Updated proposal for resolution of comments #13, #14

Adee Ran, Cisco

Figure 171–2—Functional block diagram for the PHY 800GXS

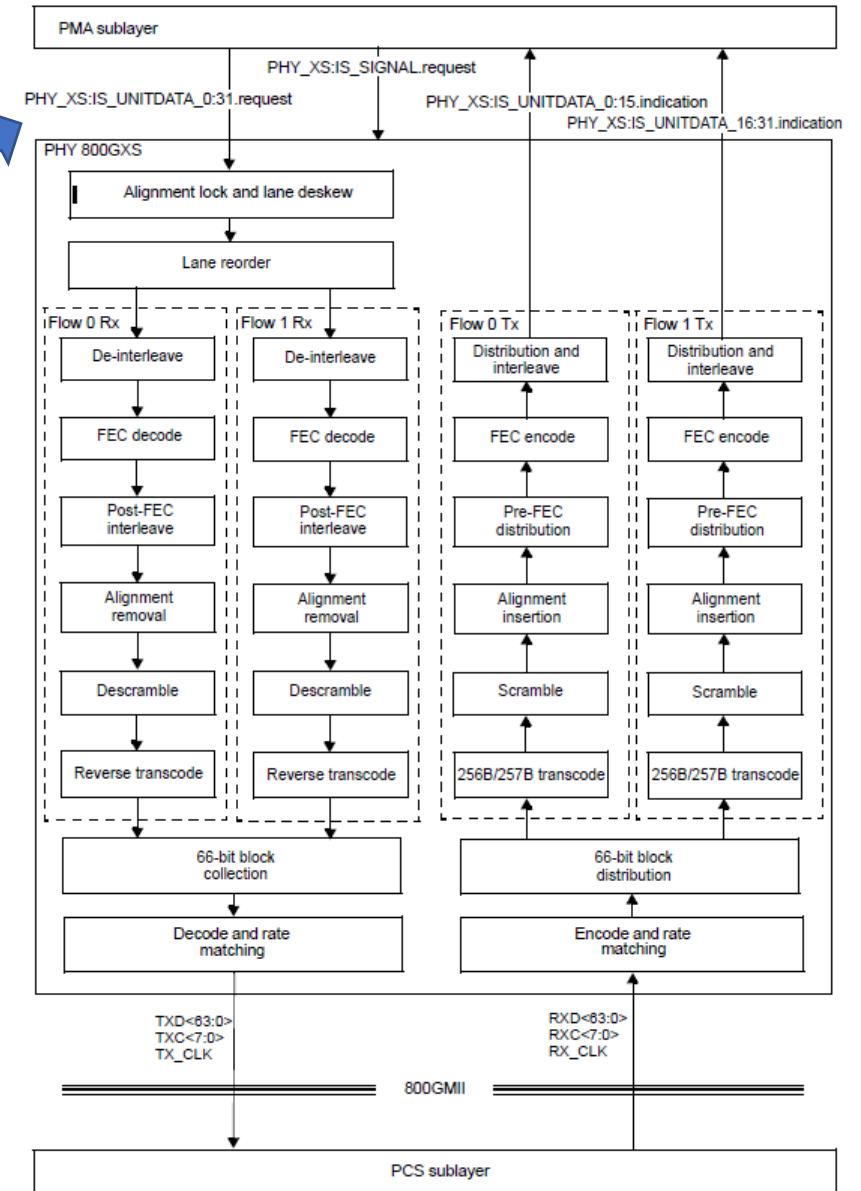
- In Figure 171–2, add an arrow for the PHY_XS:IS_SIGNAL.indication primitive towards the PMA
- The PHY 800GXS may generate this indication.

Figure 173–4—8:32 PMA functional block diagram

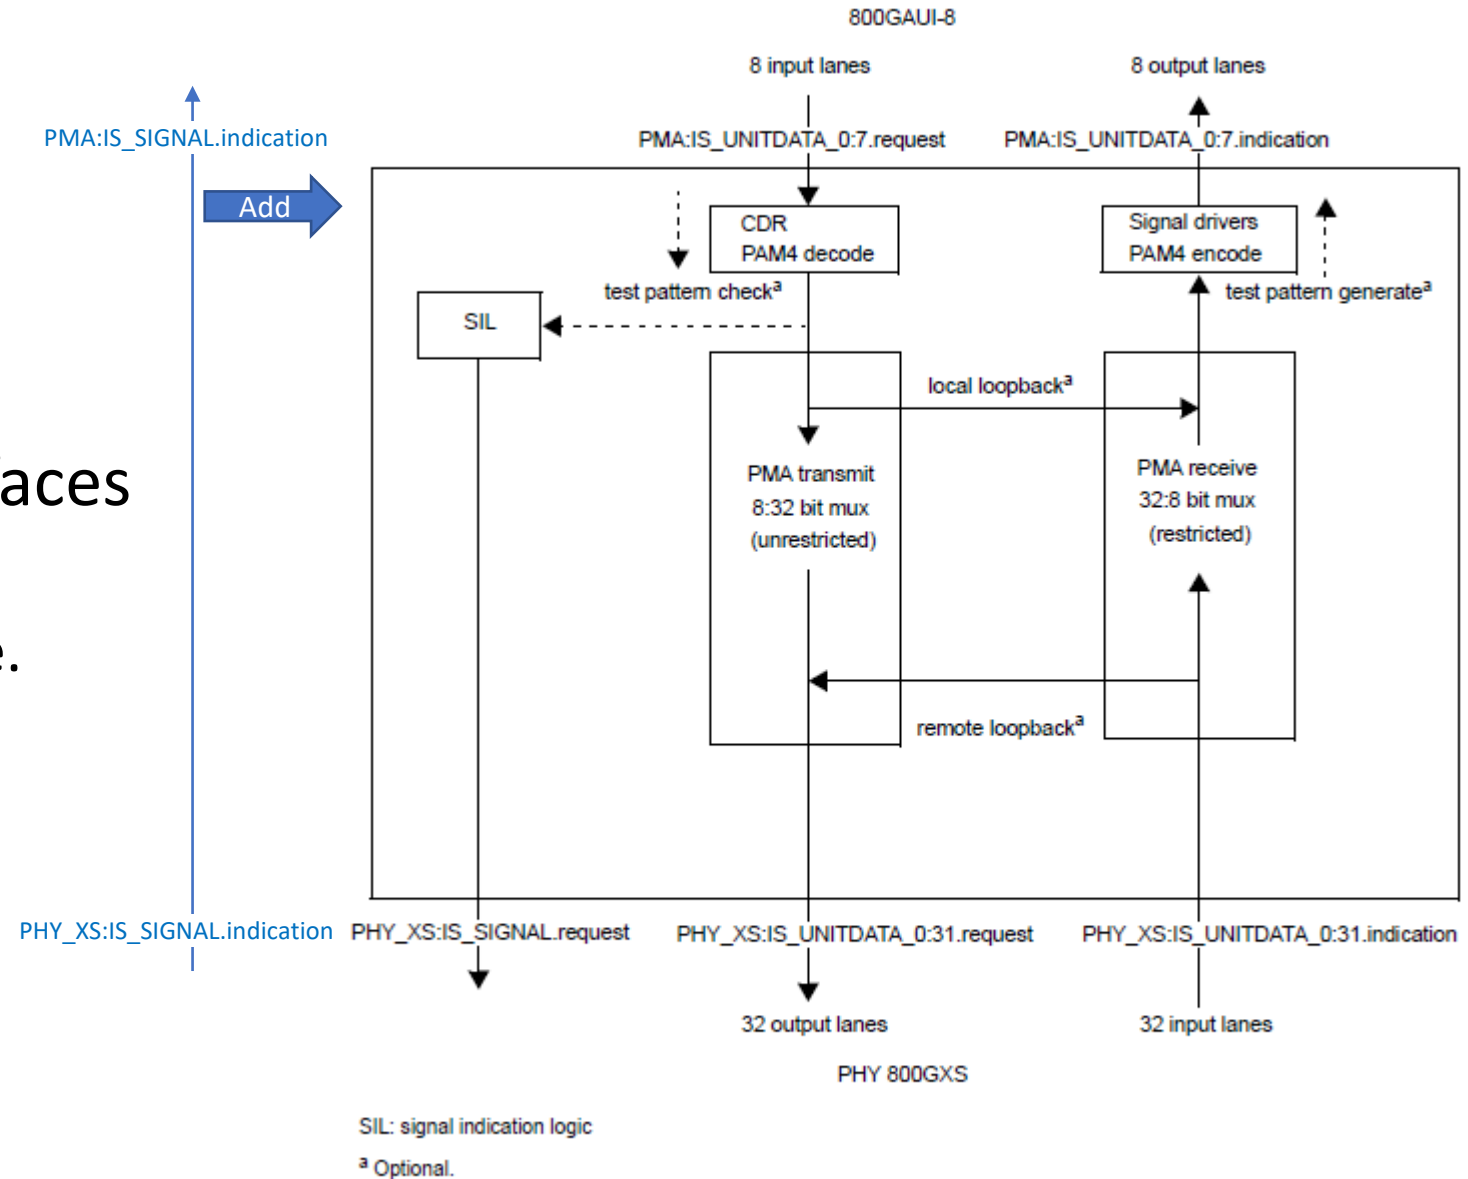
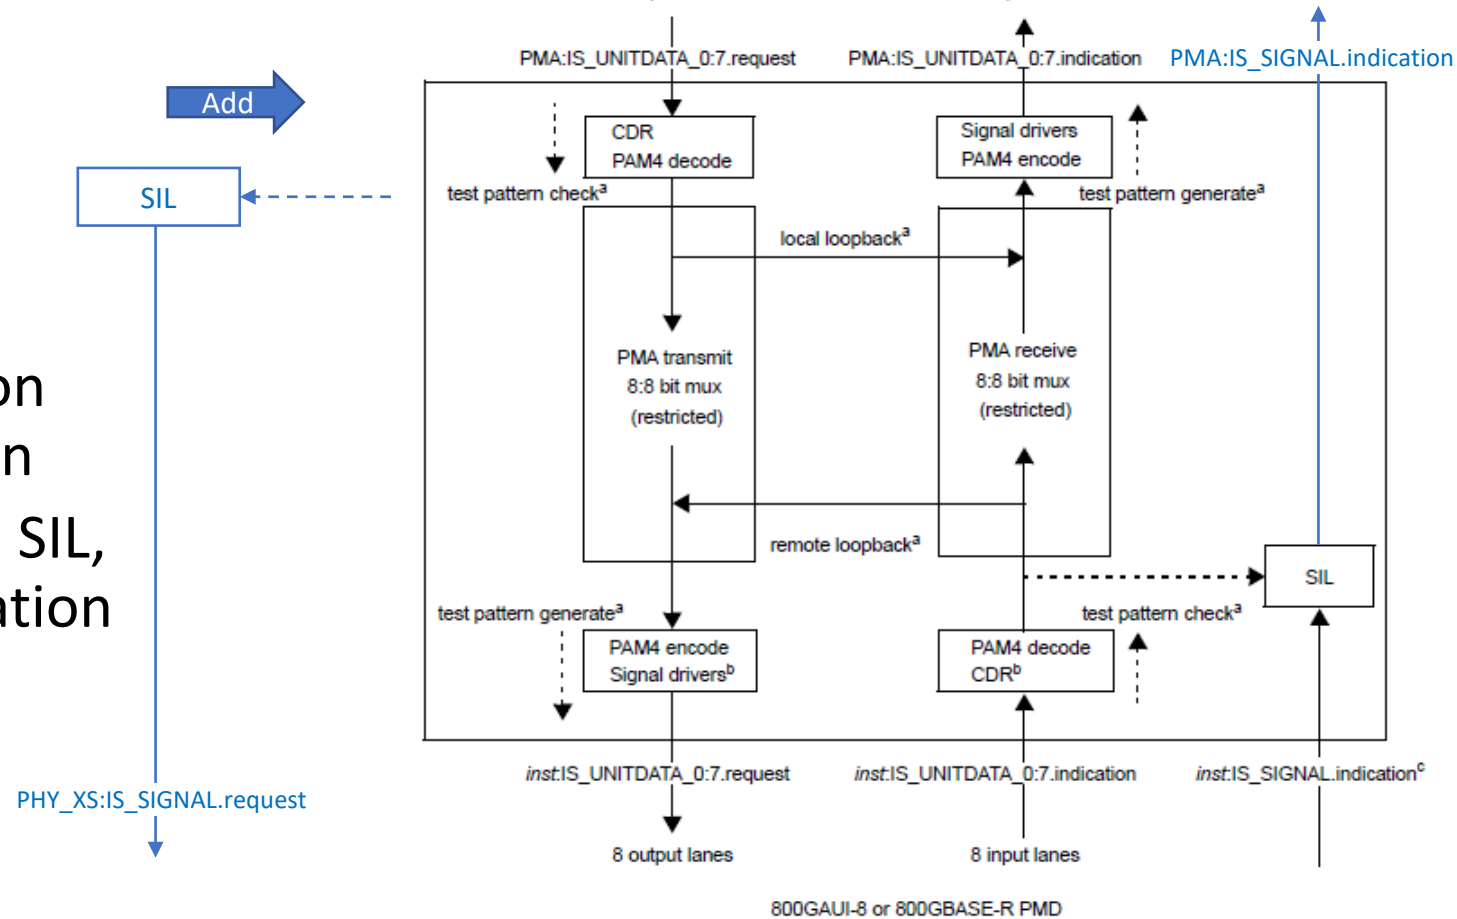
- In Figure 173–4, add IS_SIGNAL.indication interfaces and arrow.
 - No SIL required for this case.
